UNITED STATES PATENT AND TRADEMARK OFFICE

APPLICATION NO.	FILING DATE	FIRST NAMED INVENTOR	ATTORNEY DOCKET NO.	CONFIRMATION NO.
10/591,728	06/11/2007	Brian Mandt	00758.1824USWO	1718
23552	7590	01/19/2011		
MERCHANT & GOULD PC P.O. BOX 2903 MINNEAPOLIS, MN 55402-0903			EXAMINER	
			STELLING, LUCAS A	
			ART UNIT	PAPER NUMBER
			1776	
			MAIL DATE	DELIVERY MODE
			01/19/2011	PAPER

Office Action Summary	Application No.	Applicant(s)	
	10/591,728	MANDT ET AL.	
	Examiner	Art Unit	
	Lucas Stelling	1776

DETAILED ACTION

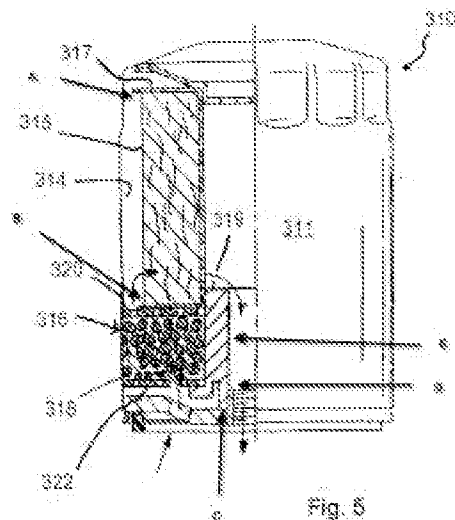
5. As to claim 1, Rohrbach teaches a service cartridge for positioning in a filter housing; the service cartridge comprising:

filter media **(315)** having a first and second ends **(A and B)** and positioned around a central opening area;

a first end cap (**part of the frame 317 constitutes an end cap of the filter**) secured to the first end of the filter media; and ,

a treatment agent storage and release cartridge **(the cartridge is defined by the upper plate 320, the lower plate 322, the sealing member 319, see also [0055], [0056], and [0057])** to the second end of the media;

the treatment agent storage and release cartridge having a ring configuration **(the filter is cylindrical)** defining an inside wall **(E)** defining a central flow conduit in liquid flow communication with the central open area defined by the filter media;

the inside wall having no diffusion apertures **(no diffusion apertures are show through the inside wall)** therethrough;

the treatment agent storage and release cartridge also having an end wall, the end wall having flow apertures therethrough **(See 322 in Fig. 5 apertures are provided)** and

a housing seal arrangement **(see C and D)**.
